SCIENTIFIC SERVICES

POST APPLICATION SCOPING REPORT AND PLAN OF STUDY FOR ENVIRONMENTAL IMPACT ASSESSMENT FOR ENVIRONMENTAL AUTHORISATION IN TERMS OF THE NEMA ENVIRONMENTAL IMPACT ASSESSMENT REGULATIONS FOR THE PROPOSED CHANGE OF LAND USE BY CONSTRUCTION OF A WATER STORAGE DAM ON FARM VAN DER WATTSKRAAL No. 394 PORTIONS 3 AND 5 AS WELL AS FARM No. 234 REMAINDER, SWELLENDAM, SWELLENDAM MUNICIPAL AREA.

DEA&DP REFERENCE #: 16/3/3/6/7/2/E3/10/1163/17

Figure 2: Map showing location of proposed alternative dam locations and weir relative to farm boundaries, vegetation units, NFEPA wetlands and locations of known streams and rivers.

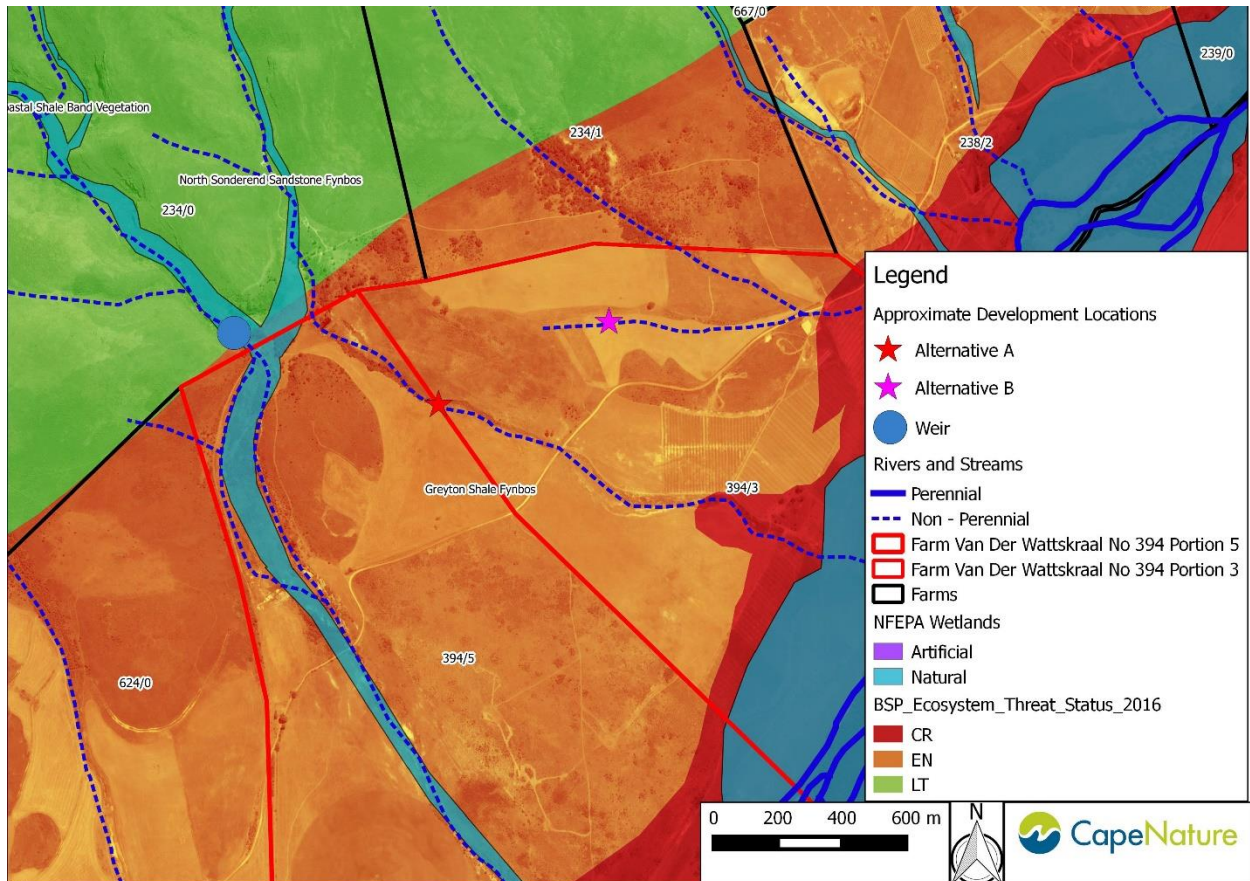
The weir and each alternative location for the dam are proposed to be built on a different non-perennial drainage lines present on the properties. Only the weir is also a Freshwater Ecosystem Priority Areas (FEPAs)⁴ (Figure 2). According to the WCBSP data, the weir is located within the Riviersonderend Mountain Catchment Area and alternative location A is proposed to be located within the extent of Critical Biodiversity Area 1: Terrestrial as well as Ecological Support Area 2 region, while Alternative B is proposed to be located within ESA 2 (Figure 3).

Figure 2: Map showing location of proposed sites relative to farm boundaries and WCBSP (2017).

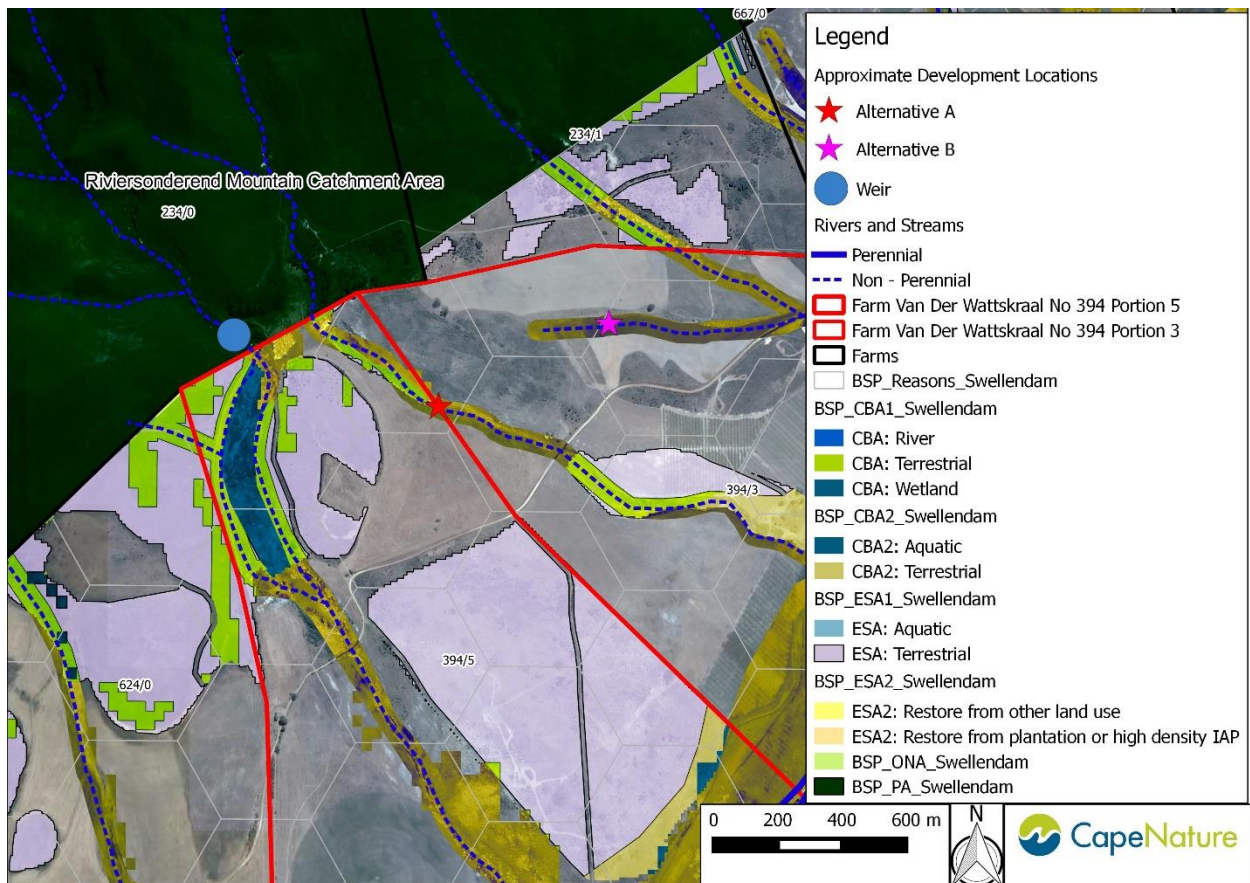
CBA areas are defined as: *“Areas in a natural condition that are required to meet biodiversity targets, for species, ecosystems or ecological processes and infrastructure.”*

CBA objectives are: *“Degraded areas should be rehabilitated. Only low-impact, biodiversity-sensitive land uses are appropriate.”* The primary reason for the CBA delineation within the area is for watercourse protection.

ESA 2 areas are defined as: *“Areas that are not essential for meeting biodiversity targets, but that play an important role in supporting the functioning of PAs or CBAs, and are often vital for delivering ecosystem services.”*

ESA 2 objectives are: *“Restore and/or manage to minimize impact on ecological processes and ecological infrastructure functioning, especially soil and water-related services, and to allow for faunal movement.”*
